# Product Change Notice (PCN)

PCN Number: **PCN-0450006R-01**

Product(s) Affected: **SJ-3503-SMT-TR**

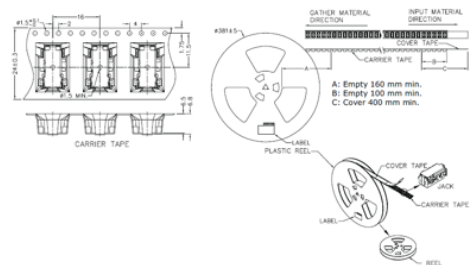
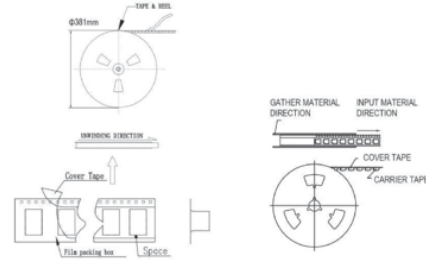
Description of Change: **Solder Profile Difference. See image Below**

PREVIOUS CUI DEVICES DETAIL / IMAGE	NEW CUI DEVICES DETAIL / IMAGE																																																
<p><b>SOLDERABILITY</b></p> <table border="1"> <thead> <tr> <th>parameter</th> <th>conditions/description</th> <th>min</th> <th>typ</th> <th>max</th> <th>units</th> </tr> </thead> <tbody> <tr> <td>reflow storage</td> <td>at relative humidity &lt;30%</td> <td></td> <td></td> <td>40</td> <td>°C</td> </tr> <tr> <td>reflow soldering<sup>1</sup></td> <td>see reflow profile</td> <td>255</td> <td>260</td> <td>265</td> <td>°C</td> </tr> <tr> <td>drying conditions<sup>2</sup></td> <td>parts in reel: bake at 40°C ±5°C for 72 hours parts removed from reel: bake at 40°C ±5°C for 10 hours</td> <td></td> <td></td> <td></td> <td></td> </tr> </tbody> </table> <p>Notes:            1. It is recommended to reflow solder within 72 hours from opening vacuum packaging at a temperature &lt;30°C &amp; relative humidity &lt;60%.            2. When exceeding four life by &gt;72 hours.</p> 	parameter	conditions/description	min	typ	max	units	reflow storage	at relative humidity <30%			40	°C	reflow soldering <sup>1</sup>	see reflow profile	255	260	265	°C	drying conditions <sup>2</sup>	parts in reel: bake at 40°C ±5°C for 72 hours parts removed from reel: bake at 40°C ±5°C for 10 hours					<p><b>SOLDERABILITY</b></p> <table border="1"> <thead> <tr> <th>parameter</th> <th>conditions/description</th> <th>min</th> <th>typ</th> <th>max</th> <th>units</th> </tr> </thead> <tbody> <tr> <td>reflow storage</td> <td>10-30°C, &lt;70% humidity</td> <td></td> <td></td> <td></td> <td>°C</td> </tr> <tr> <td>reflow soldering<sup>1</sup></td> <td>see reflow profile</td> <td>255</td> <td>260</td> <td></td> <td>°C</td> </tr> <tr> <td>drying conditions<sup>2</sup></td> <td>parts in reel: bake at 110°C for 4 hours parts removed from reel: bake at 110°C for 4 hours</td> <td></td> <td></td> <td></td> <td></td> </tr> </tbody> </table> <p>Notes:            1. CUI Devices recommends to solder within 72 hours from opening vacuum packaging at a temperature &lt;30°C &amp; relative humidity &lt;60%.            2. When exceeding four life by &gt;60 hours.</p> 	parameter	conditions/description	min	typ	max	units	reflow storage	10-30°C, <70% humidity				°C	reflow soldering <sup>1</sup>	see reflow profile	255	260		°C	drying conditions <sup>2</sup>	parts in reel: bake at 110°C for 4 hours parts removed from reel: bake at 110°C for 4 hours

parameter	conditions/description	min	typ	max	units																																												
reflow storage	at relative humidity <30%			40	°C																																												
reflow soldering <sup>1</sup>	see reflow profile	255	260	265	°C																																												
drying conditions <sup>2</sup>	parts in reel: bake at 40°C ±5°C for 72 hours parts removed from reel: bake at 40°C ±5°C for 10 hours																																																
parameter	conditions/description	min	typ	max	units																																												
reflow storage	10-30°C, <70% humidity				°C																																												
reflow soldering <sup>1</sup>	see reflow profile	255	260		°C																																												
drying conditions <sup>2</sup>	parts in reel: bake at 110°C for 4 hours parts removed from reel: bake at 110°C for 4 hours
